## **REMARKS/ARGUMENTS**

Application No. 10/799,780 Reply to Office Action of November 10, 2005

## **REFERENCE FIG. 1**

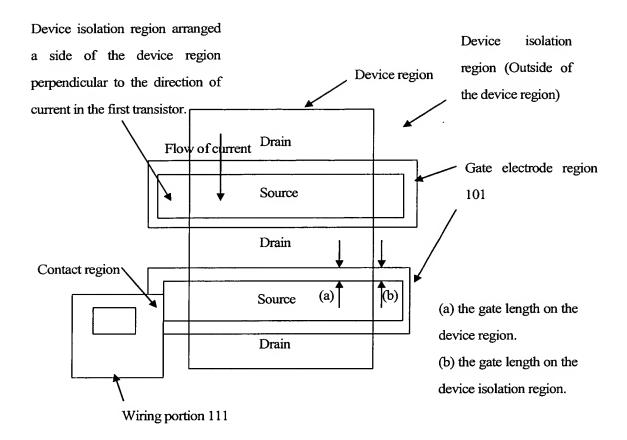
Applicants respectfully traverse the objection to the drawings as not showing the subject matter of Claim 8. Claim 8 recites,

8. The semiconductor device of claim 1, wherein respective loop-shaped gate electrode regions have same lengths on the device region and a device isolation region except contact regions between wiring portions and the gate electrode regions.

Thus, in Claim 8, the loop-shaped gate electrode region has same length on the device region and the device isolation region. As shown in Reference Figure 1 presented on the next page of this paper, (a) is the gate length on the device region and (b) is the gate length on the device isolation region. The "exception" in Claim 8 regarding the contact regions between the wiring portions and the gate electrode regions arises because the length of the contact portion connected to the wire portion of the loop-shaped gate electrode is sometimes lengthened for secure connection to the wire portion, as shown in the left bottom portion of the Reference Figure 1. This structure further distinguishes over the Kumagai reference, which in Fig. 4A shows a gate 108a which has shorter channel region (right side) than others. Nevertheless, it is respectfully submitted that the subject matter of Claim 8 is shown in Figure 1 of the present application, and withdrawal of the objection to Claim 8 is respectfully requested.

have the same length and/or with respect to what exception. In response, Claim 8 has been amended to delete reference to "the" in referring to "respective loop shaped gate electrode regions." Further, as explained above in regard to the above Reference Figure 1, in this figure, (a) is the gate length on the device region and (b) is the gate length on the device isolation region, as is believed apparent to persons skilled in the art from Figure 1 of Applicants' disclosure. Accordingly, the rejection of Claim 8 under of 35 USC §112, 2<sup>nd</sup> para., is believed to have been overcome. If the Examiner disagrees, the Examiner is requested to clarify the basis of the rejection and/or make suggestions as to how this ground for rejection can be overcome.
